**RE: 14341 Browns Lane**

I reviewed the drawings and evaluated the neighborhood context. My comments and recommendations on the design are as follows:

PROPOSED PROJECT

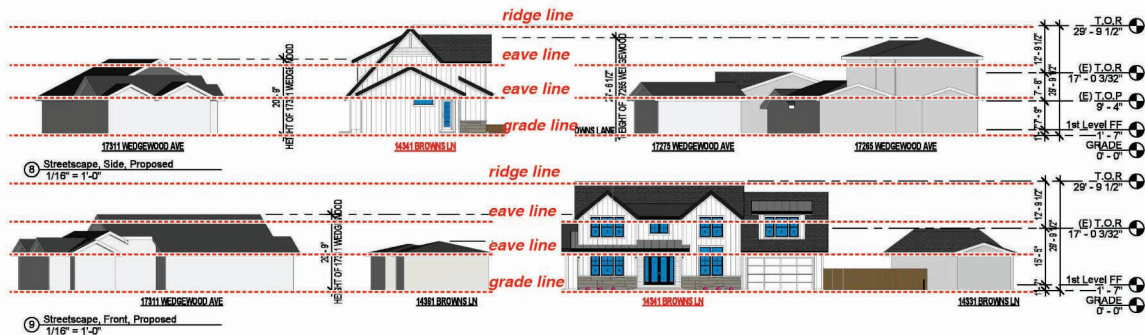
1. The stone base and divided light windows are two elements that are proposed on the front facade but not carried consistently around the other home facades. This would not be consistent with Residential Design Guideline 3.2.2.

2. There is a distinction shown on the drawings for two roof areas on the front and rear facades that have no descriptive notes so it is hard to anticipate their appearance in the context of the other roofs.

3. The garage door material is not described. If it is a glass and metal door, as it appears it might be on the drawings, it may not be consistent with Residential Design Guideline 3.4.1.

1. Stone and/or divided light windows utilized on the front facade should be carried around consistently on all facades consistent with Residential Design Guideline 3.2.2. If the divided light windows are used, they should be true or simulated divided windows consistent with Residential Design Guideline 3.7.4. See example illustrations below.

2. Clarify the materials for the two roof elements which are currently not clearly described.
3. Clarify the proposed garage door materials. Solid panels are recommended.

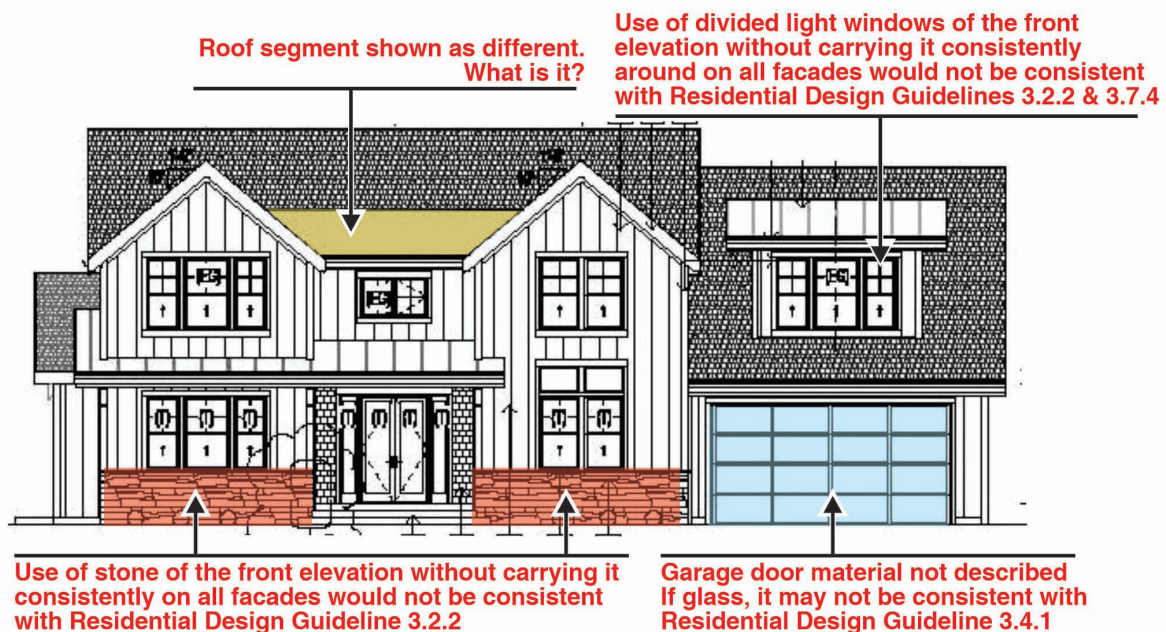
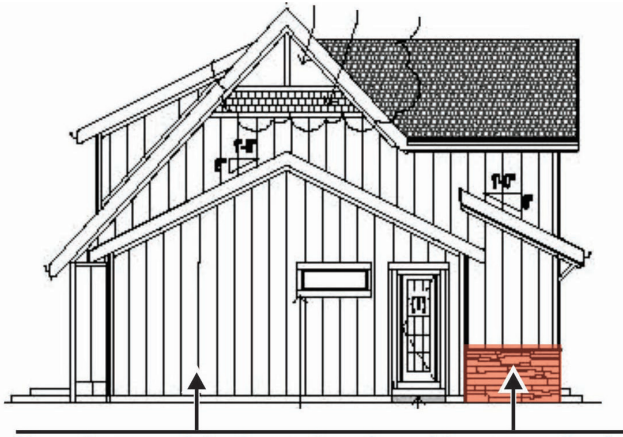
**Use of stone of the front elevation without carrying it consistently on all facades would not be consistent with Residential Design Guideline 3.2.2**

**Roof segment shown as different.  
What is it?**
